PITT-05-20-026

**Re: DEP FILE E11-352-A1
Technical Deficiency Response
Pennsylvania Pipeline Project – Mariner East 2
Goldfinch Lane HDD and Reroute Major Amendment
Application No E11-352-A1
APS No. ID No. 876467
Jackson Township, Cambria County, PA**

Comments and Responses to May 5, 2020 Technical Deficiency Letter as provided in Attachment D:

Culvert Performance Curve Plot: Culverts 1-4

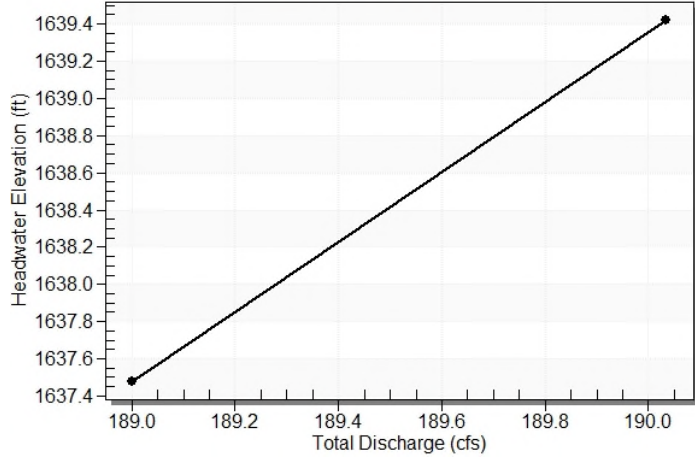
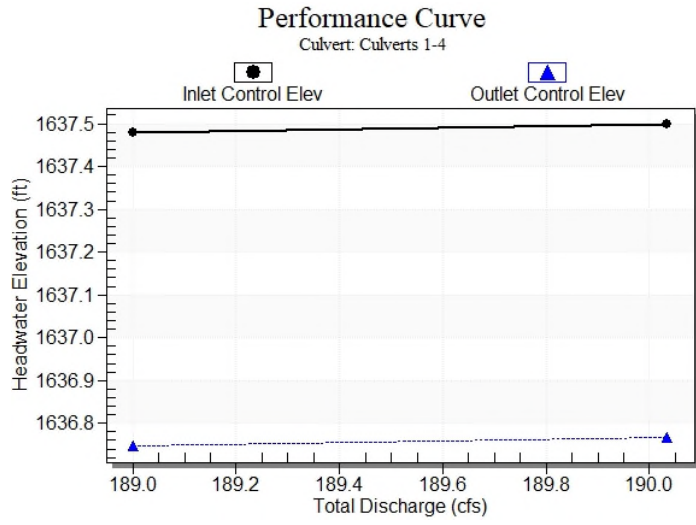
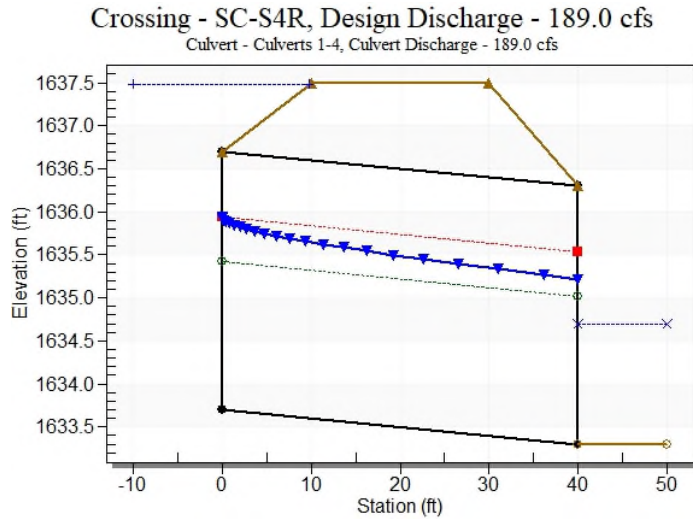
- 2 . §105.13(e)(1)(x): Please describe how the pipeline will be installed beneath Hinckston Run as it is reported to be roughly 30-feet wide. A pump-around will not work in this location due to the size of the watercourse. Additionally, please ensure all watercourse and wetland crossings for this amendment are located on the resource crossing table on Sheet ES-0.02 as they are not seen.
Status: The design has been revised to use a flume pipe bypass. Please provide the hydraulic information for the flume pipe size that will convey the normal flow of the stream

With this in mind, 36" pipes (slightly more than twice the normal depth) were chosen as the culvert size needed, and this assumed culvert size was checked to ensure capacity. Based on the bottom channel depth of 20' and the required minimum spacing dictated by Table 3.5 of the Pennsylvania Department of Environmental Protection's Erosion and Sediment Pollution Control Program Manual, dated March 2012, it was determined that 4 culverts could be placed across the stream channel, while maintaining appropriate spacing of at least 18" between culverts. Potentially placing 5 culverts was examined, however, it was determined that to place 5 culverts, excavation of the channel banks would be required. 4 culverts are being proposed, as the channel integrity is maintained while adequately passing the flow.

The FHWA's HY-8 program was used to calculate the flow through the culverts at this location, based on the geometry of the channel and the dimensions of the proposed culvert. HY-8 confirmed that the assumption of four 36" culverts would adequately pass the flow without overtopping.

TYPICAL PIPELINE INSTALLATION STREAM CROSSING – DRY FLUME DETAIL
NOT TO SCALE

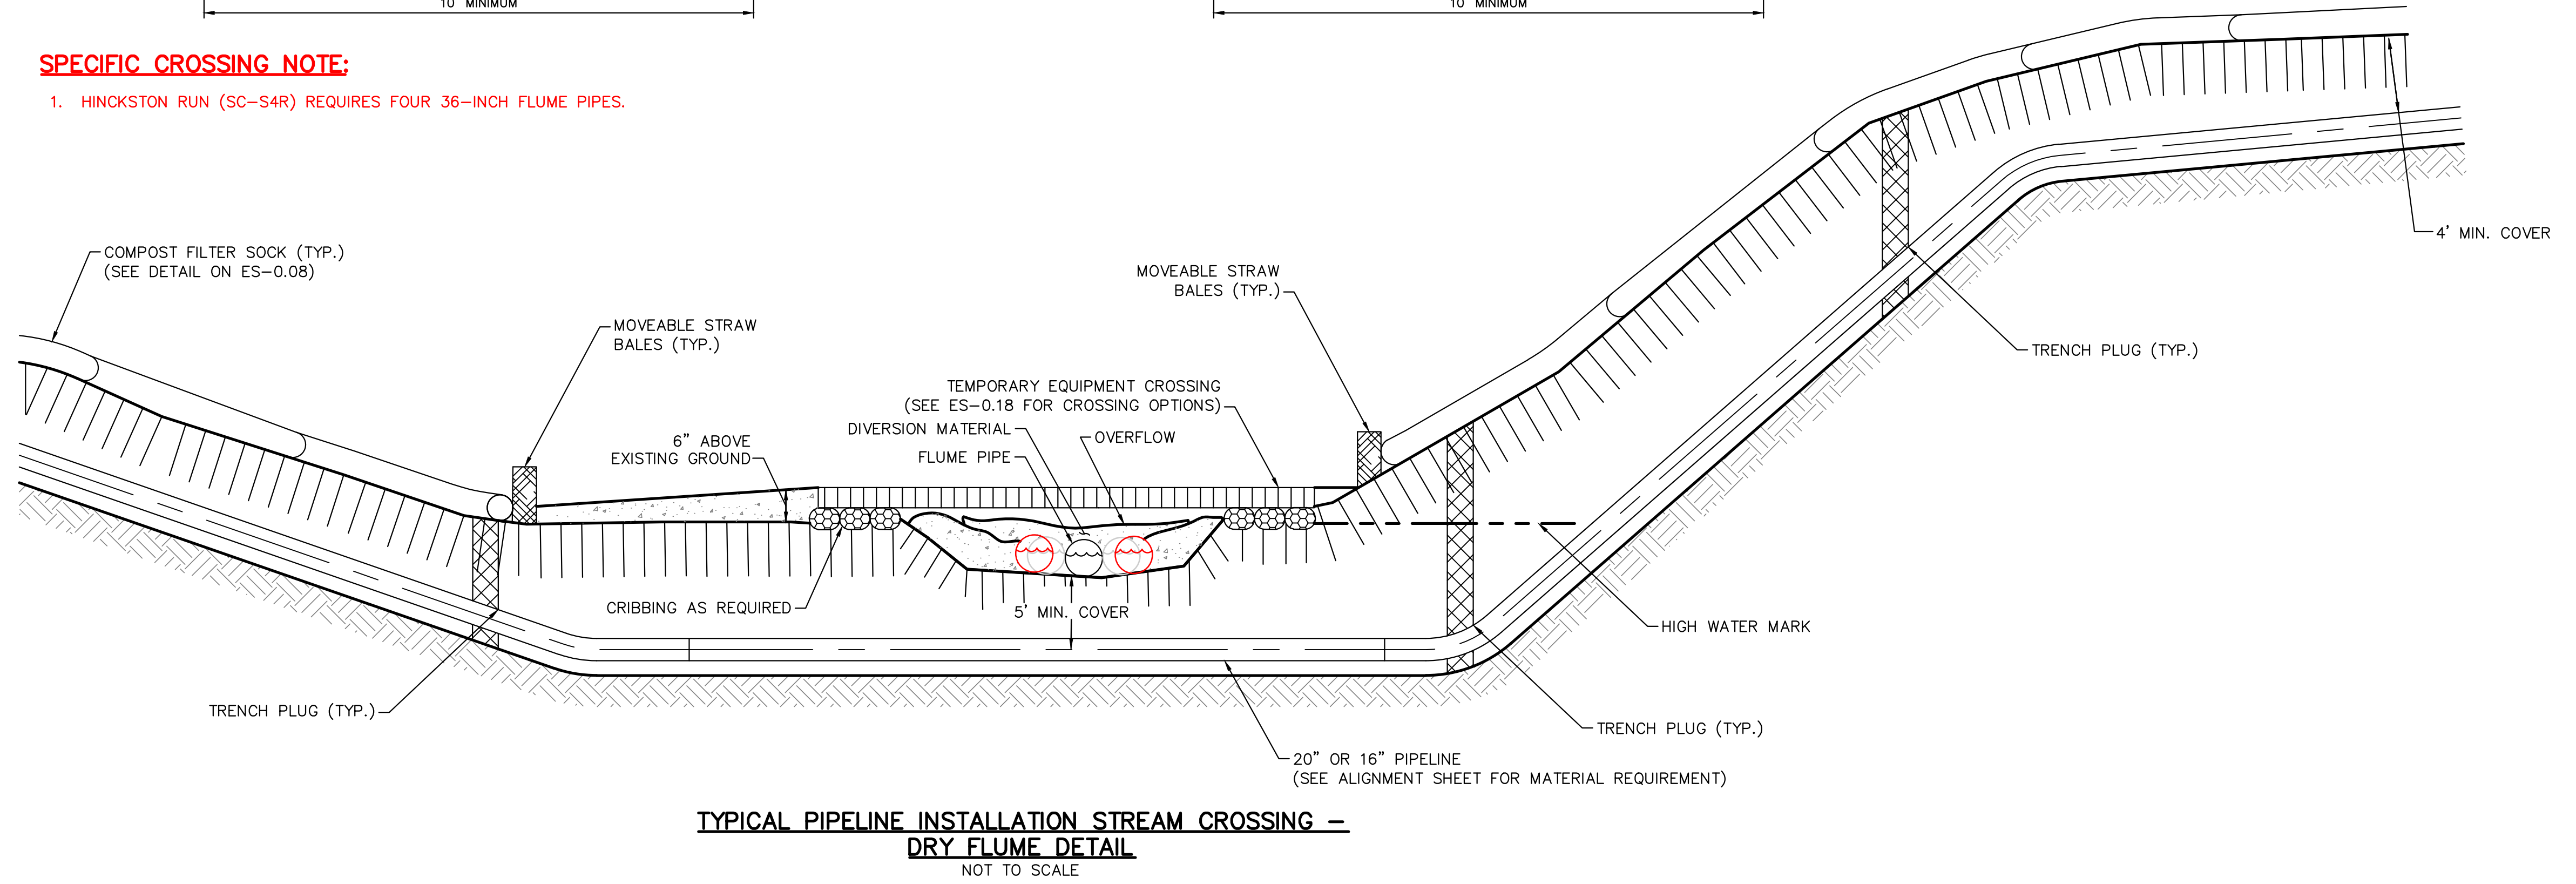
with a detail for spacing if multiple flume pipes will be implemented. (The current detail shows the pipe against each other with inadequate spacing per the E&S Manual.) Ensure this revision has been included within the ESCGP-3 updated E&S plan sheets.

Response: Attachment B of this Technical Deficiency response provides the calculation worksheet for Hinckston Run for the sizing of the flume pipes and associated hydraulic information. Additional field survey information identified that Hinckston Run has a bottom width of 20 feet, top width of 26 feet, and a normal water depth of 1.4 feet at the crossing location. As shown in the evaluation, four 36-inch flume pipes will pass the flow without overtopping. In addition, E&S Plan Set sheets ES-0.12 and ES-0.18 have been revised to provide the spacing information associated with the pipes and include a note to identify Hinckston Run (SC-S4R) bypass will require four 36-inch flume pipes. These plans are provided in Attachment C.

- HINCKSTON RUN (SC-S4R) REQUIRES FOUR 36-INCH FLUME PIPES.
